# **CLAREMONT TRAFFIC AND TRANSPORTATION COMMISSION MEETING AGENDA**

5. MOUNTAIN AVENUE CORRIDOR (BASE LINE ROAD TO BONITA AVENUE) COMPLETE STREETS PROJECT UPDATE - RESPONSE TO PUBLIC COMMENTS

**MOUNTAIN AVENUE CORRIDOR (BASE LINE ROAD TO BONITA AVENUE) COMPLETE STREETS PROJECT UPDATE - RESPONSE TO PUBLIC COMMENTS**

### **Responses to Public Comment**

### Alt 2:

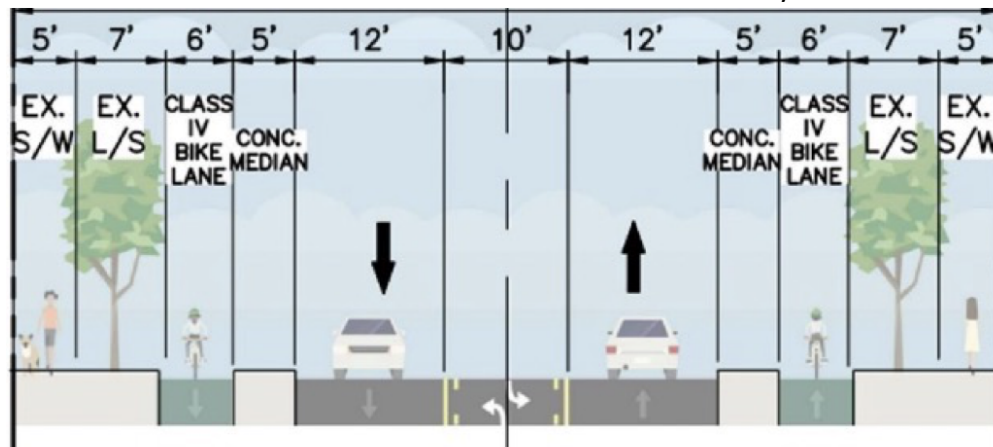
Alternative 2 embodies the mistaken notion that Class IV bike lanes would necessarily eliminate all parking. This design suggests, without evidence or justification, that a raised median needs to be a minimum of 5ft wide and that a center turn lane is necessary.

### Alt 3:

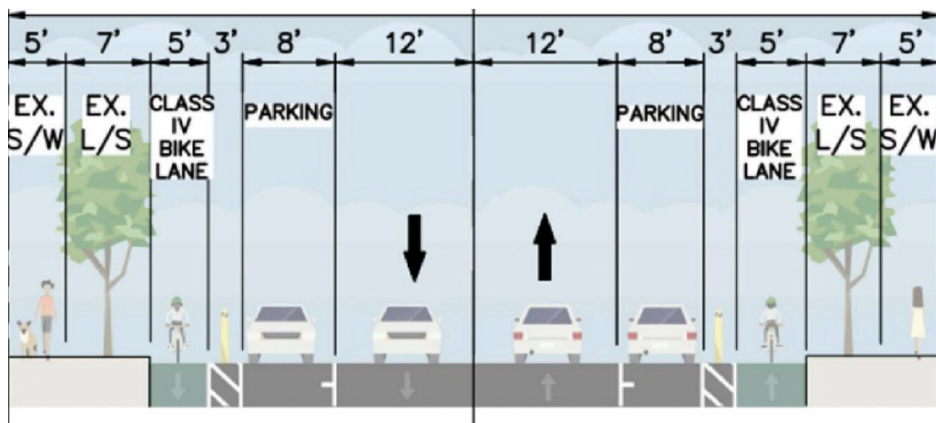
On the same slide, an alternative appeared that CSP believes is the safest of those provided by the consultants. Alt 3 does not have a center turn lane, does provide parking on both sides of the street, and creates a 3 ft buffer (not a median) between the parking and the Class IV bike lane. This

provides bikes with protection: distance from speeding cars, protection by parked cars, and distance from parked car doors.

### Cross Section

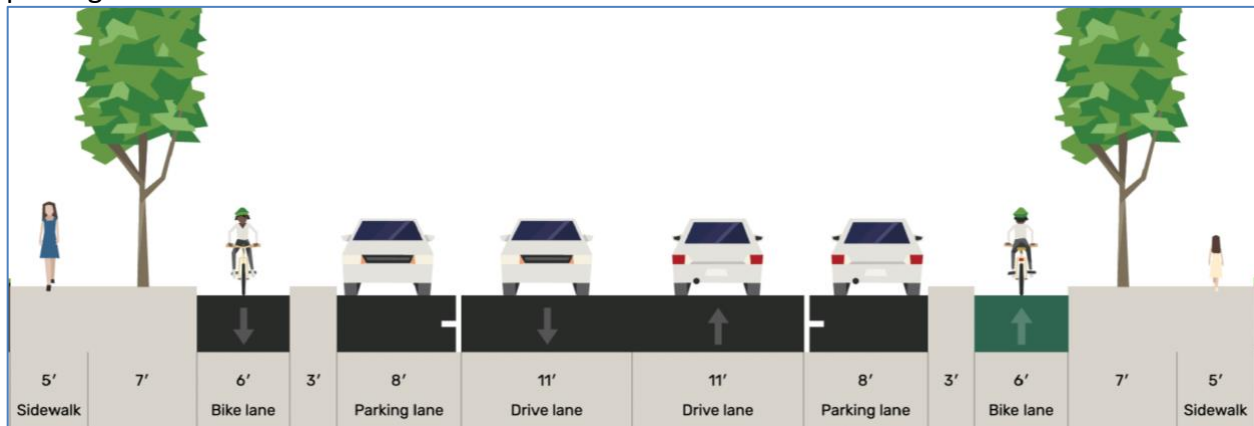
Below is the cross-section – directly from the drawings – for the majority of the project (Harrison to Baseline). It is the same basic cross section as currently exists from Harrison to Foothill, and similar to Mills Ave as well. These road segments have not had good crash records.

Recommendations by citizens in the January 24, 2023 Council meeting included protected bike lanes and a 2-lane street (no center turn lane). The following general cross-section demonstrates an approach that is absent from the current drawings, creating protected bike lanes while keeping parking on both sides.

- Protected bike lanes are notably safer and will attract more users than unprotected lanes.
  - Bike lanes can be protected by a parking lane as shown above, or by planters, curbs, and bollards, as demonstrated in the Federal Highway Administration's Bike Lane Guide<sup>1</sup>. The Guide also cites that "any type of buffer shows a considerable increase in self-reported comfort levels over a striped bike lane" (p. 83).

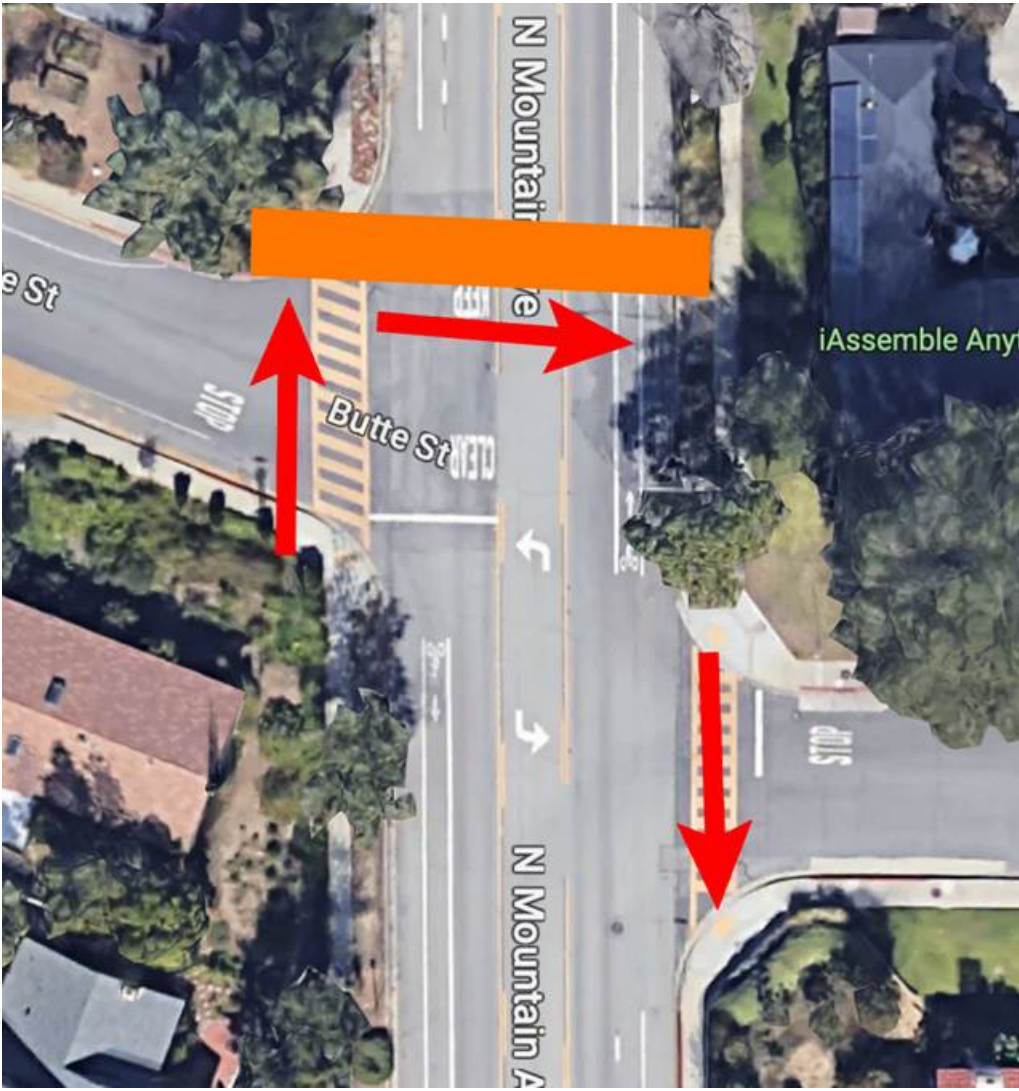
One of my biggest concerns with the current Mountain design, and the one proposed in the 30% plan, is the inability for cyclists and pedestrians to easily cross Mountain between Foothill and Harrison. Butte/8th is a natural place to cross for many in the neighborhood on the east of Mountain, but crossing Mountain is often a bit of a game of frogger.

Butte/8th is also currently designated as a bike-priority zone. However, crossing Mountain at this intersection is actually quite difficult for cyclists.

The 30% design includes a new crosswalk on the north corner of Butte, crossing into the middle of the block on Mountain. (see the crosswalk placement in orange in the first image below).

Phil Ebner	<p>While the planned crosswalk bump outs and flashing lights will help pedestrians cross, I believe the south corner of Butte is a better place for this crosswalk (see placement in pink in the second image below).</p> <p>There are several reasons for this:</p> <ol style="list-style-type: none"> <li>1. The crosswalk would naturally go from one street corner to another, instead of from one corner into the middle of a neighbor's parkway.</li> <li>2. Visibility of the crosswalk and accompanying flashing lights will be better in the southern location, especially for drivers traveling on Butte/8th.</li> <li>3. For students traveling to El Roble via foot or bike, they would only have to make 1 street crossing to get cross Mountain instead of 2 (Butte &amp; Mountain)</li> <li>4. Cyclists (especially those with kids) who want to safely cross Mountain at this intersection would have to cross 3 streets with the current design plan. Cyclists traveling east or west would be able to safely use the crosswalk, while also only having to cross 2 streets to continue their travel.</li> </ol> <p>To sum up, the new design of Mountain Ave needs to improve the ability for pedestrians, cyclists, &amp; cars to safely cross Mountain between Foothill &amp; Harrison. This particular intersection of Butte/8th &amp; Mountain is a problematic one. But I believe a crosswalk on the southern corner of Butte to the northern corner of 8th could solve this issue.</p>	Location of this crosswalk will be reassessed in the revised 30% design.

**ALTERNATIVE CROSS SECTION (A)**

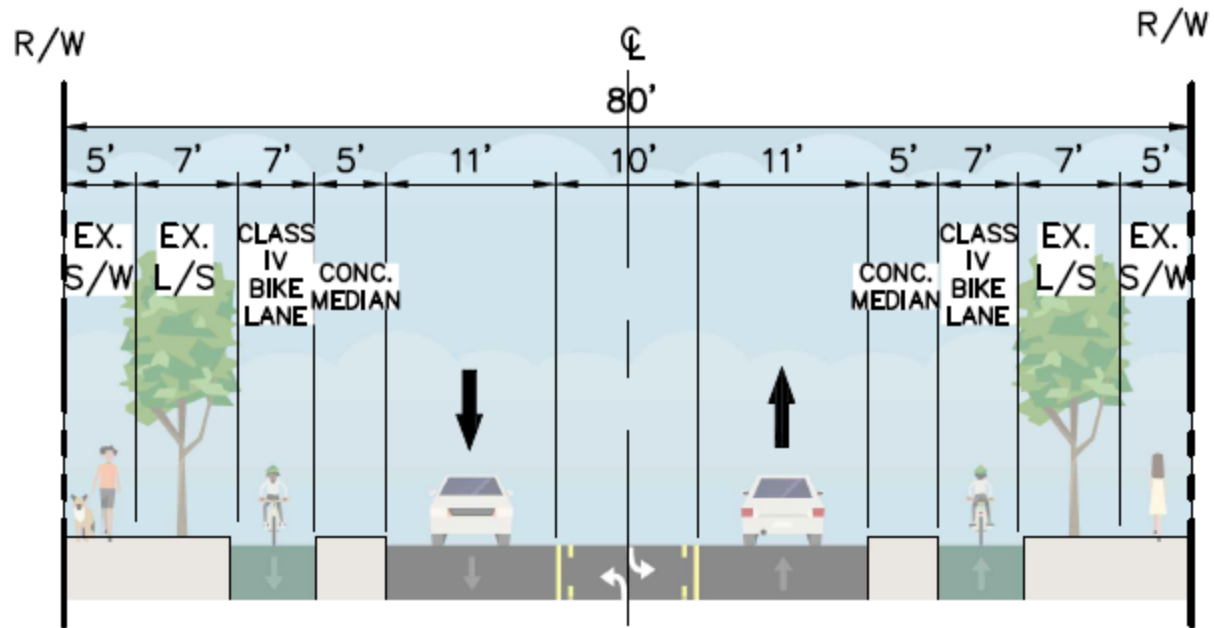
01:25:13 Katie Marker	spoke to the number of accidents she has witnessed on Mountain this year so far. She is in favor of having more than class one bike lanes on Mountain Avenue.	o Alternative A shows how raised concrete medians will remove all on-street parking from Mountain Ave. The Claremont Streets for People (CSP) proposed design where parking is maintained with the raised concrete medians will not be ADA compliant when the Accessibility Guidelines for Pedestrian Facilities in the Public Right-of-Way (PROWAG) is adopted by the U.S. Department of Transportation and the U.S. Department of Justice (anticipated 2024). The design for this project will likely be completed in 2024, and will therefore need to follow these standards.

01:48:21 Hannah, college student	compared the traffic volume of Mountain Avenue to College Avenue and provided her experience as a cyclist and pedestrian on Mountain Avenue. She is in favor of removing the left turn lane and parking in order to have protected bike lanes.	• Also, if a resident requests accessible parking in front of their home, the City would have to remove the new raised median facilities and construct ADA compliant facilities to accommodate accessible parking. This is not a feasible request for the City to accommodate if the raised median Class IV bike lane is installed.

**ALTERNATIVE CROSS SECTION (B)**

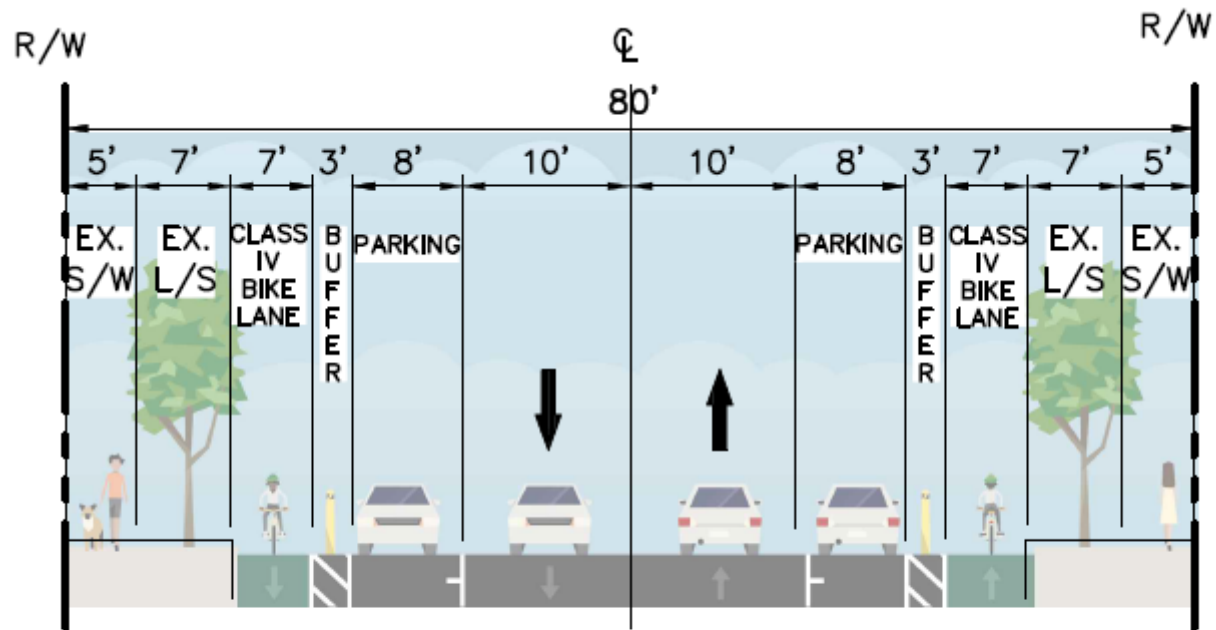
01:07:30 Paul Steinberg, Professor at Harvey Mudd College	spoke to the advantages of having a protected bike lane.	Class IV bike lanes or protected bike lanes – The City and KOA have given due consideration to protected bike lanes for Mountain Avenue. Please see the two new alternative concept plans prepared. Alternative A illustrates a Class IV bike lane with a raised concrete buffer and no on-street parking. Alternative B illustrates a striped buffer with raised bollards (but could be designed with a raised concrete buffer). There are several factors that indicate Class IV bike lanes are not feasible for this project:
Roundtree, Professor at the University of Redlands and resident	is in favor of protecting bicyclists and pedestrians from traffic and reducing water run-off.	• Mountain Avenue is primarily a residential street with houses fronting the majority of the project site. As expressed by residents who live on this street, on-street parking is essential for these residents. As shown in Alternative A, Class IV bike lanes would remove all on-street parking and Alternative B would significantly reduce the amount of on-street parking available.

- Future ADA requests cannot be accommodated if Class IV bike lanes are installed.
- Alternative B requires the removal of the center left turn lane, which is consistent with Mobility Element of the City's General Plan.

- The Mobility Element, evaluated Mountain Avenue as one of the City's special streets. Removing the center turn lane would require an amendment to the General Plan and would also require further studies, via environmental impact review.
